UNITED STATES PATENT AND TRADEMARK OFFICE

APPLICATION NO.	FILING DATE	FIRST NAMED INVENTOR	ATTORNEY DOCKET NO.	CONFIRMATION NO.
10/568,534	02/17/2006	Yasuhiro Nukisato	11630545PUS1	5031

Office Action Summary	Application No.	Applicant(s)	
	10/568,534	NUKISATO ET AL.	
	Examiner	Art Unit	
	Tung X. Le	2821

DETAILED ACTION

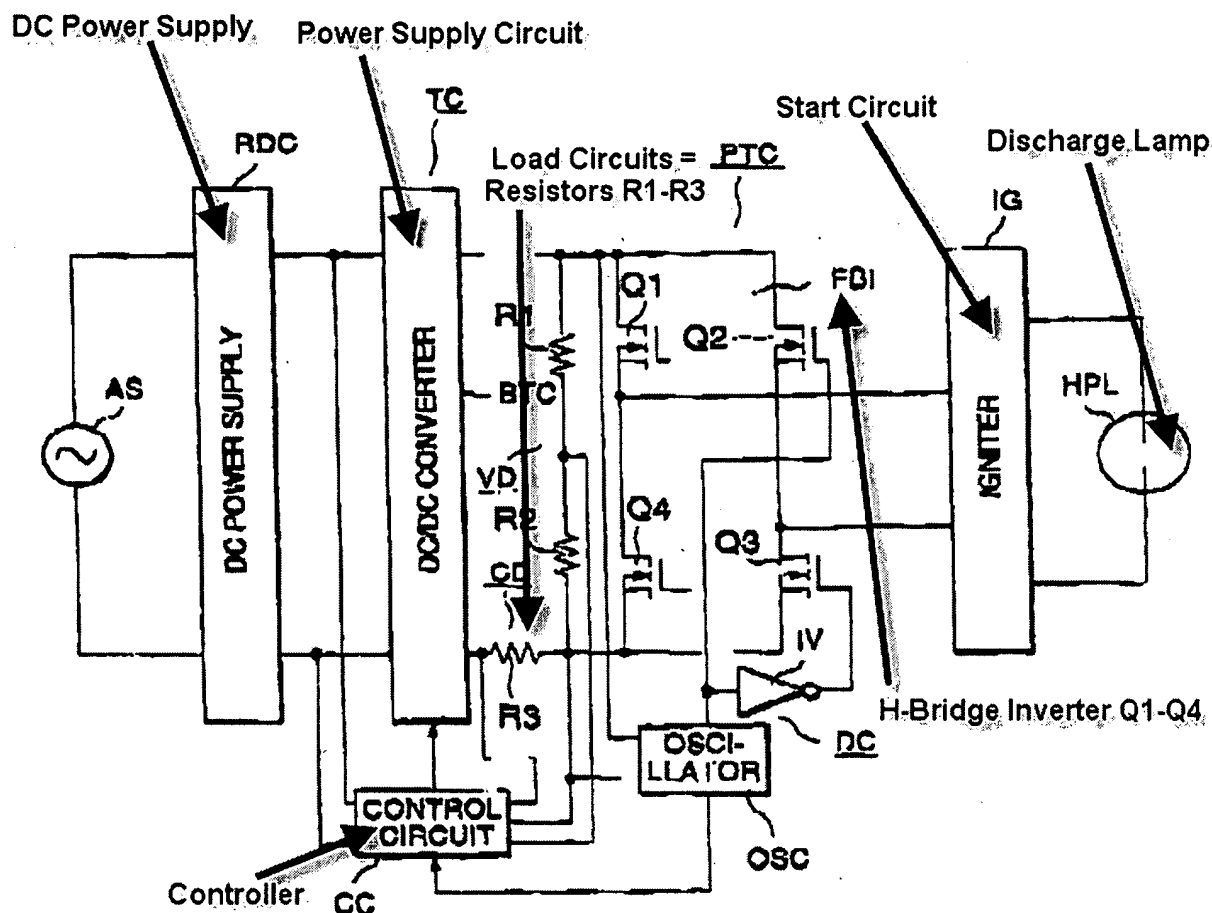
4. Claim 1 is rejected under 35 U.S.C. 102(b) as being anticipated by Yuda et al. (U.S. 6,504,323 B2).

With respect to claim 1, Yuda discloses in figure 6 a discharge lamp ballast apparatus comprising a power supply circuit (TC – DC/DC converter) for converting a voltage from a DC power supply (RDC – DC power supply), which is connected to a plurality of load circuits (a plurality of load circuits [R1-R3] connecting to the power supply circuit and the DC power supply), and for converting the prescribed DC voltage (the input DC voltage of the inverter [Q1-Q4]) to an AC voltage (an output AC voltage of the inverter) to be supplied to a discharge lamp (HPL); a start circuit (IG – igniter) for generating a high voltage pulse (column 12, lines 64-65) and for superimposing the high voltage pulse on the AC voltage to start discharge of the discharge lamp (HPL); and a controller (CC – control circuit) for controlling a current (an output current supply of the DC power supply [TC]) supplied from the DC power supply in response to a total value of currents (column 12, lines 30-55) flowing through the plurality of load circuits (R1-R3).
